Facilities & Operations Committee Meeting September 2026

RE: North Penn High School BP-2
Change Order Request #23 ASI 01 – Additional Shaft wall

PROJECT: *(name and address)* North Penn High School Renovations Bid Package 2	**CONTRACT INFORMATION:** Contract For: Mechanical Construction Date: 08-14-2026	**ASI INFORMATION:** ASI Number: 01 Date: 01-20-2026
OWNER: *(name and address)* North Penn School District 401 E. Hancock Street Landsdale, PA 19446	**ARCHITECT:** *(name and address)* Hord Coplan Macht, Inc. d/b/a SCHRADERGROUP Studio 555 E. North Lane, Suite 5100 Conshohocken , PA 19428	**CONTRACTOR:** *(name and address)* JBM Mechanical, Inc 3273 Gun Club Road Nazareth, PA 18064

Drawing Number:
BP2-A708

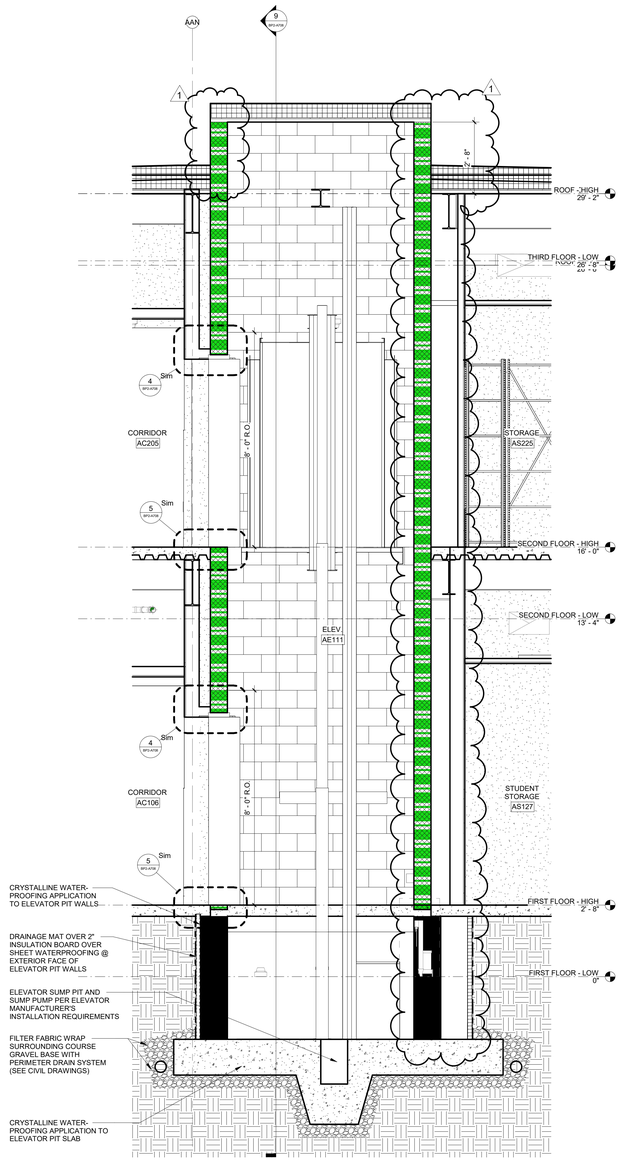
Please see below the costs associated with the changes listed in ASI 01, issued 01-26-2026. This proposal includes providing and installing an added Layer of 1" Shaft Liner to Elevator Doors per Details 4 and 6/BP2-A708.

- **Added Layer of 1" Shaft Liner to Elevator Doors per Details 4 and 6/BP2-A708 of ASI-001.**

Revisions to Structrual Set:
- Modifications to structural steel framing adjacent to elevator shaft shall be made per revised sheet BP2-A708 and reflected on Revise & Resubmit For Record submittals.

Drawing Number:
BP2-A111.A2

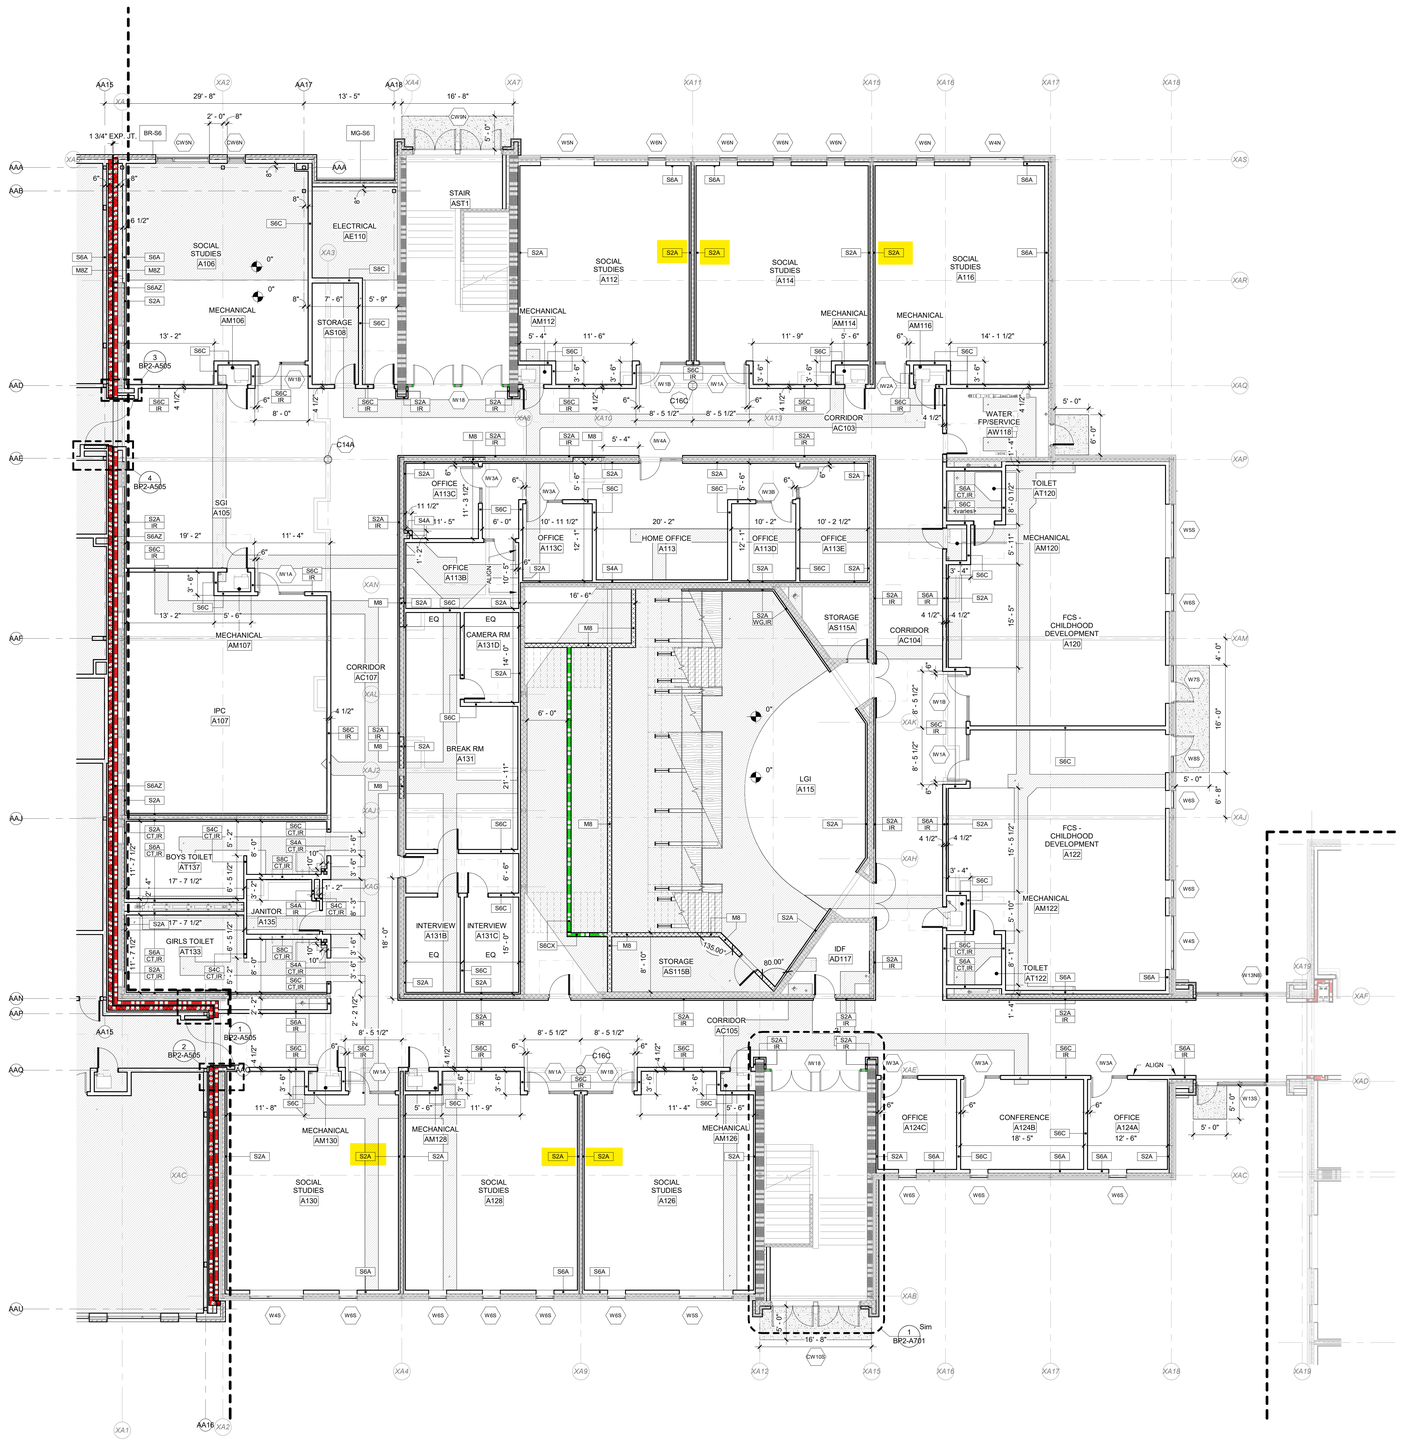
16.01 Architectural BP2-A110 Series Drawings: Revise Classroom AV wall partition type to S4A in lieu of S2A.

Drawing Number:
BP2- C017

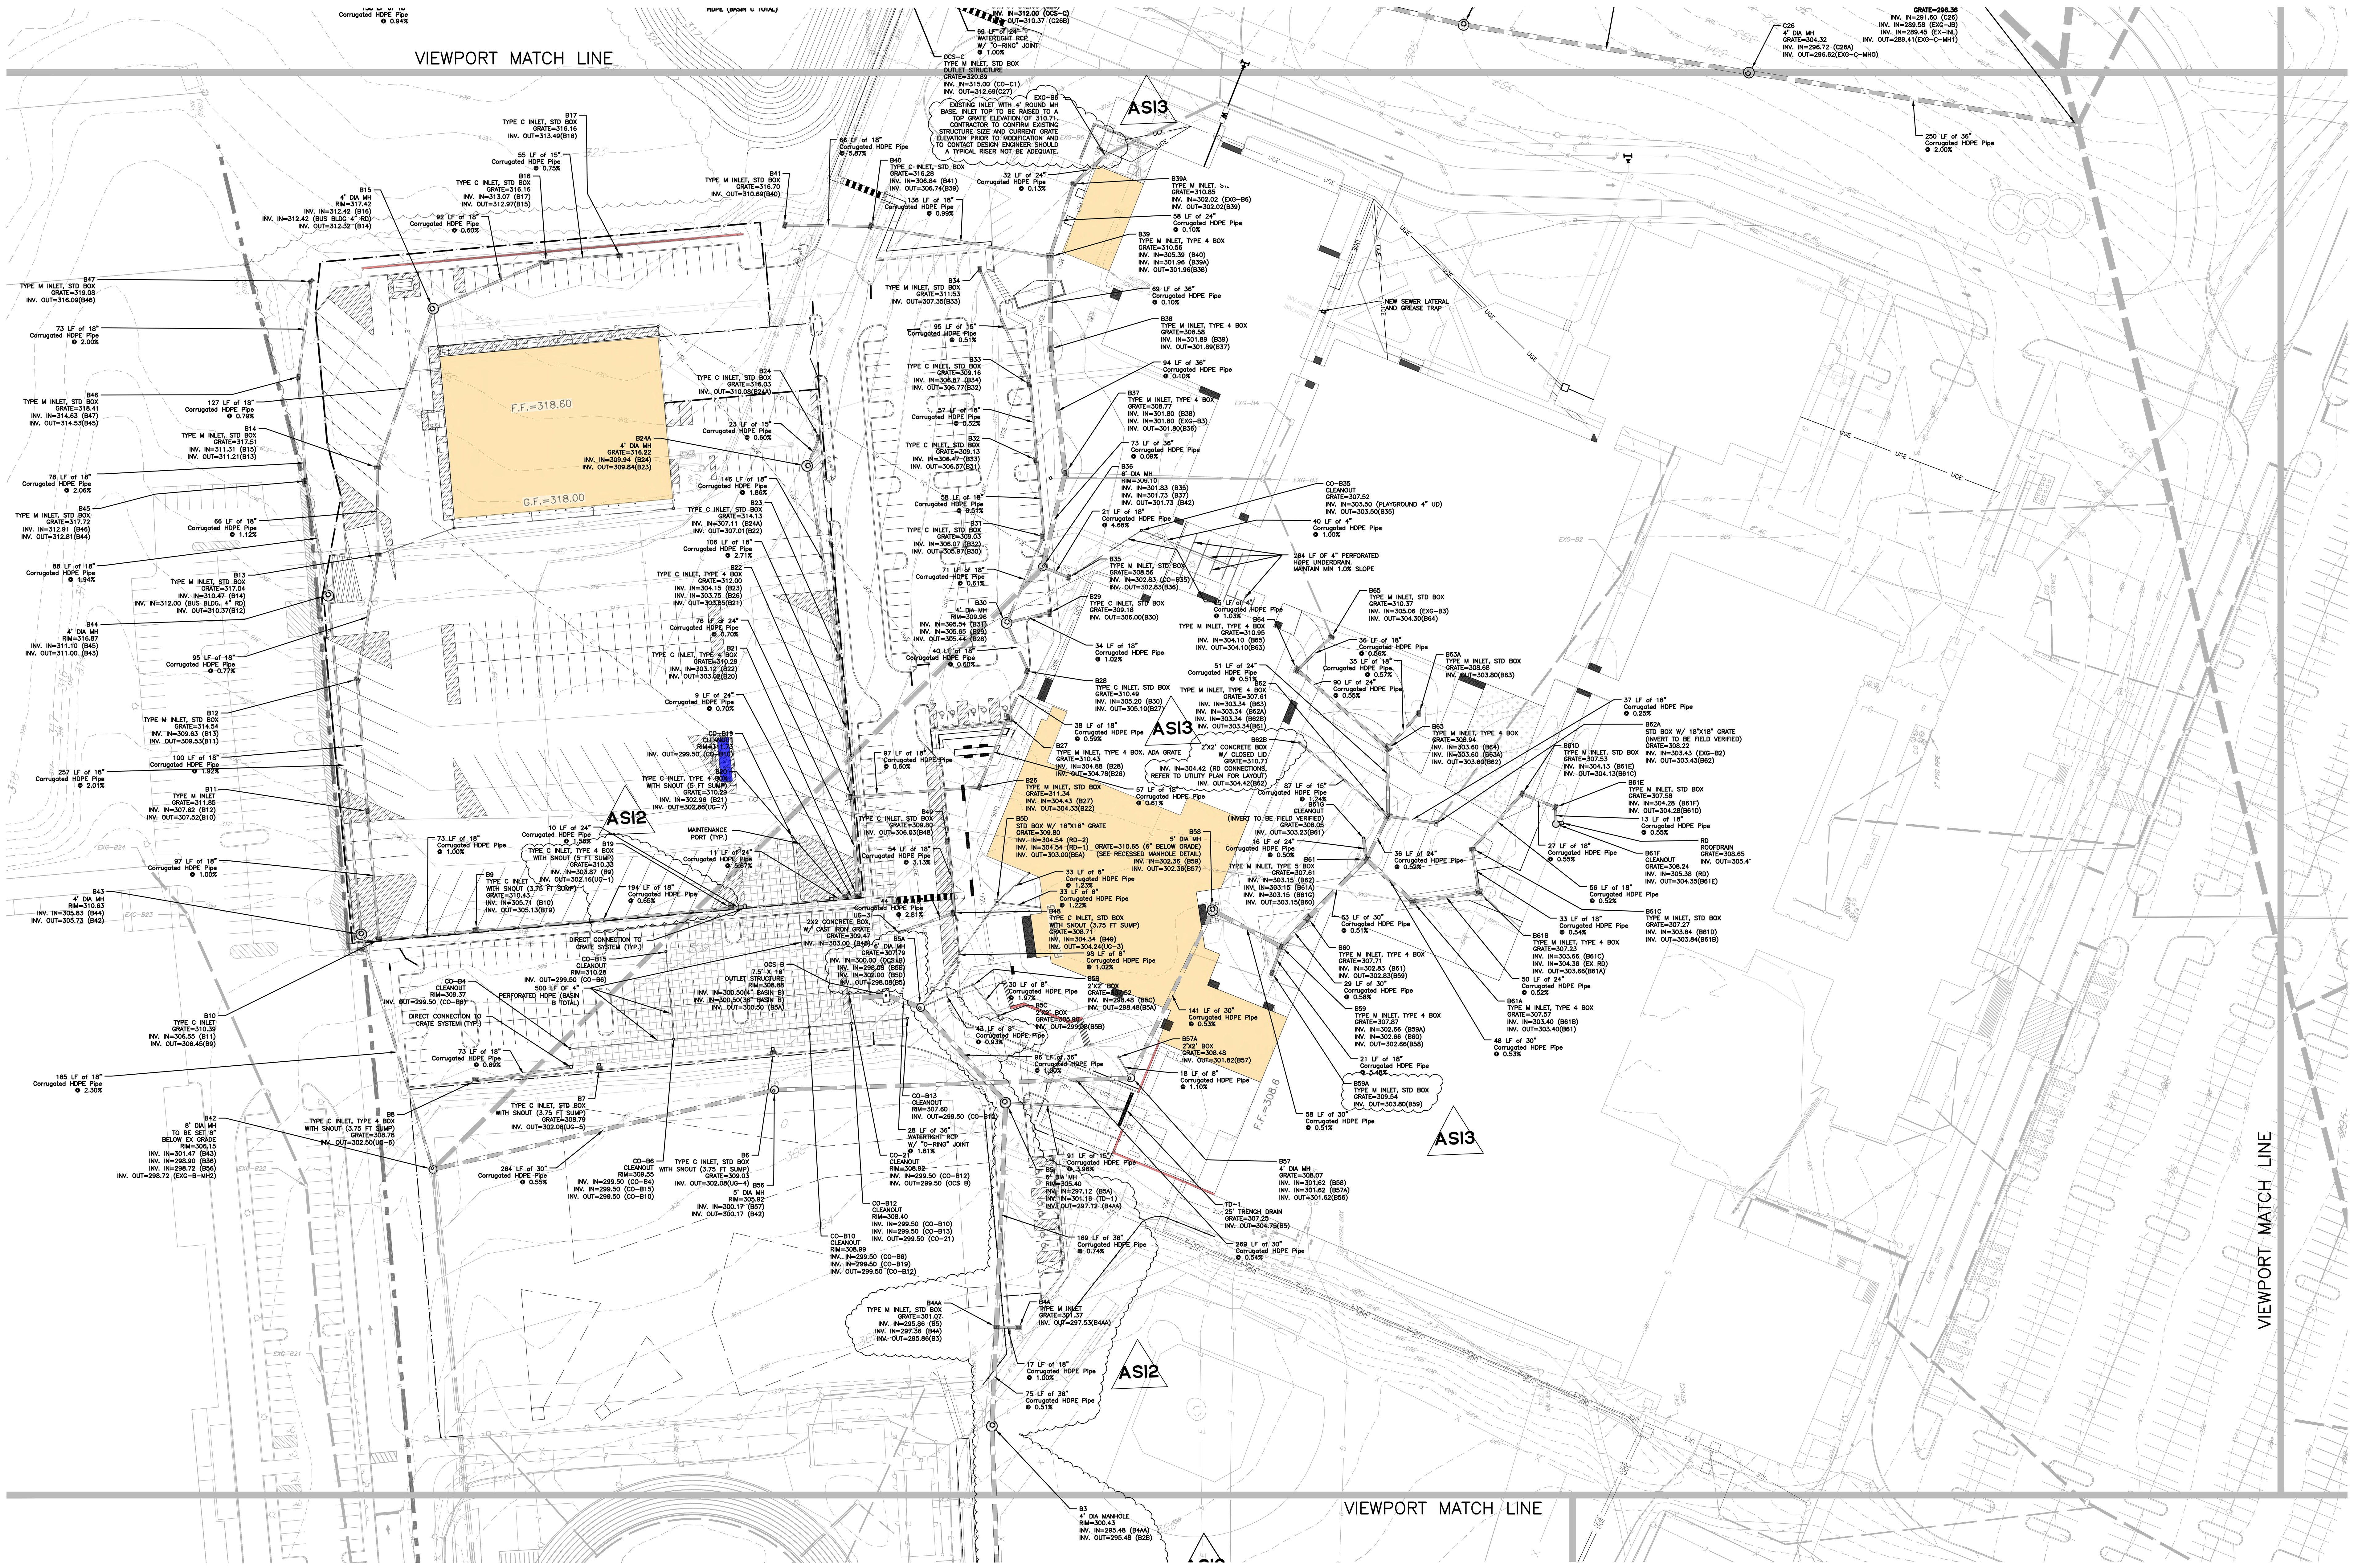
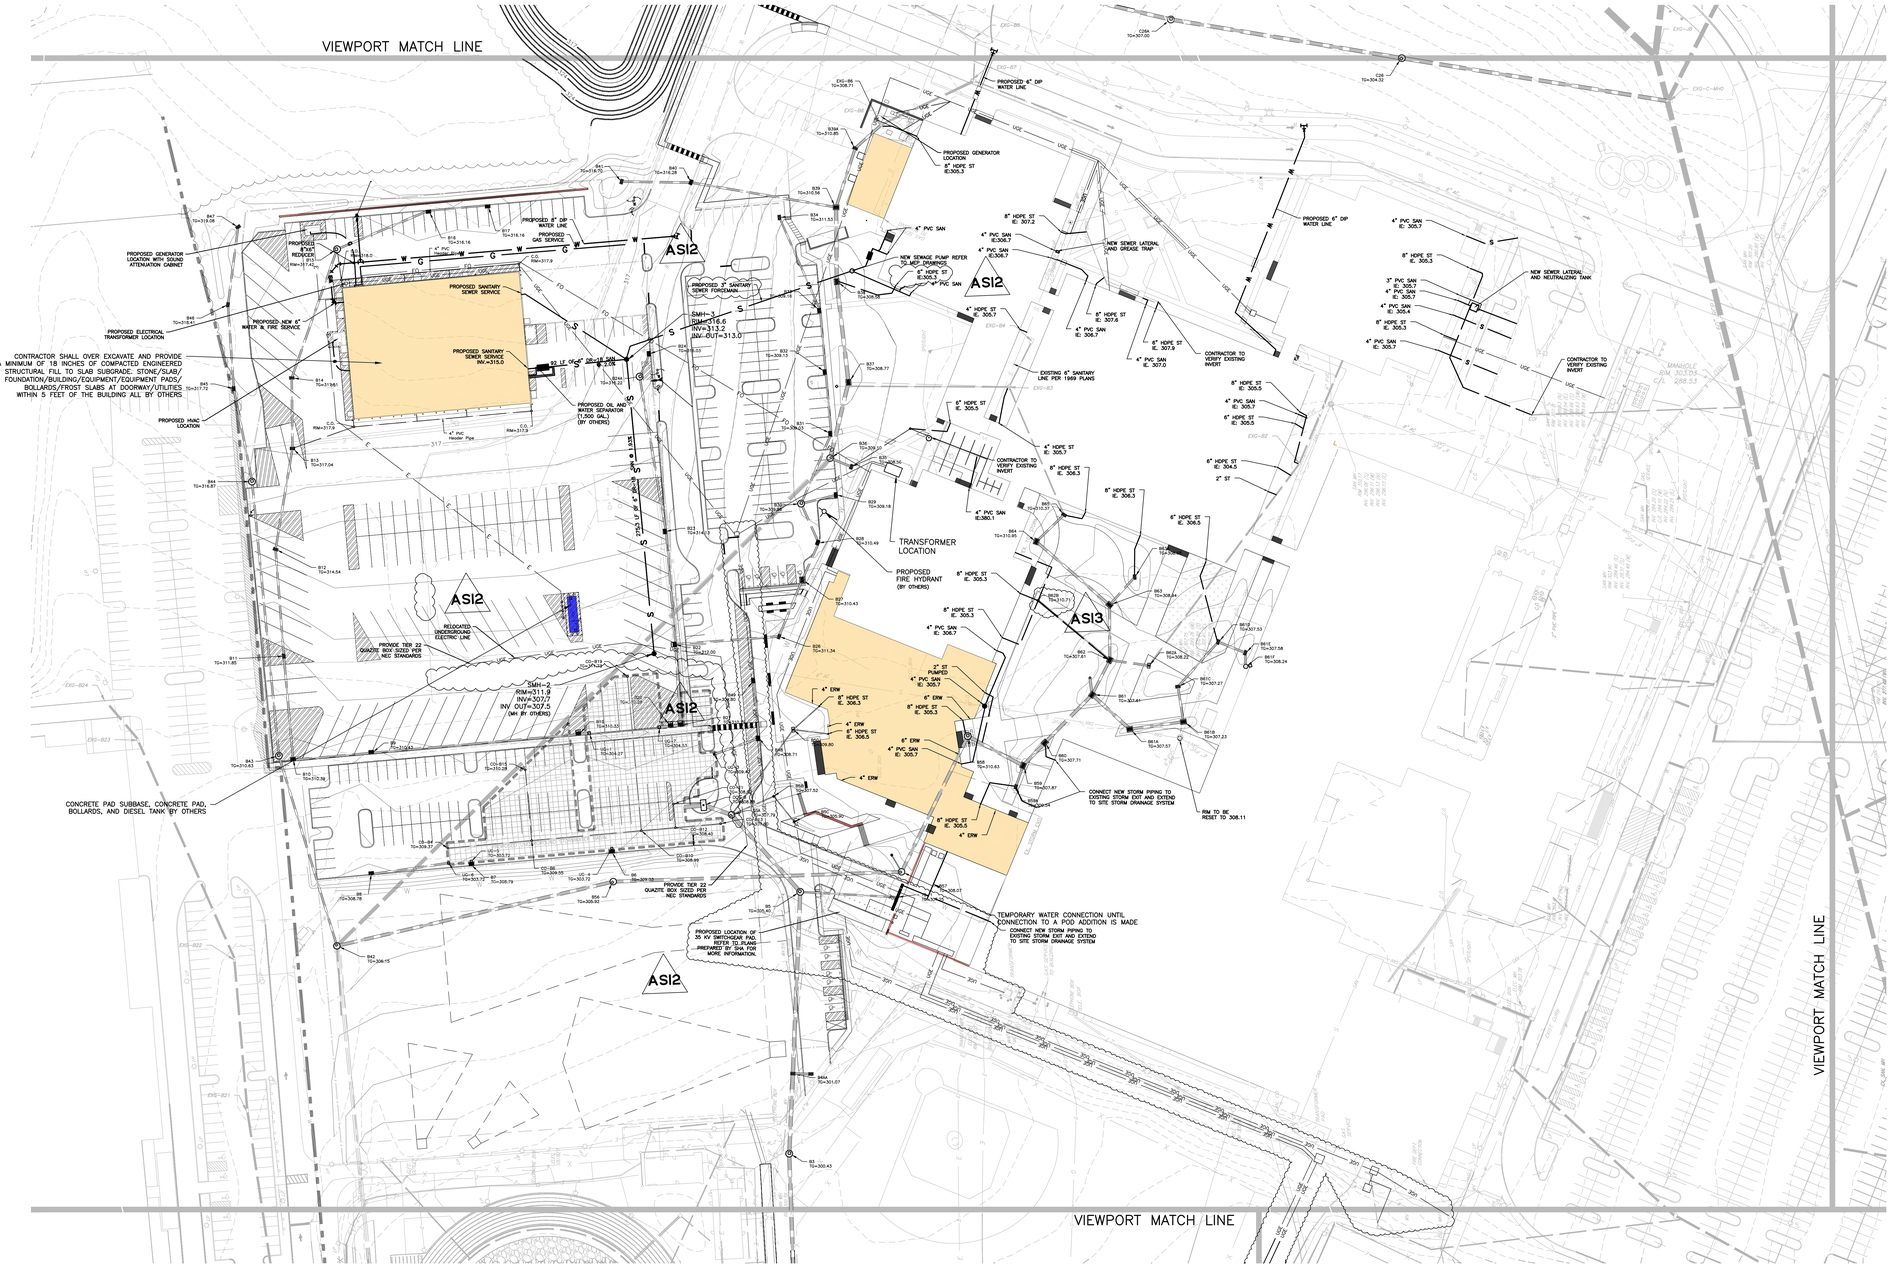
3. Drainage Plan A (BP2-C017) has been modified to make plan revisions including but not limited to:
    - **To add 2'x2' structure B62B to the courtyard storm network to connect roof drains to structure B62.**
    - **To raise B59A by 1' to work with revised courtyard grading. This will not affect the structure's shop drawing.**

- **To raise the existing inlet in Area B Equipment Yard to allow proper drainage**
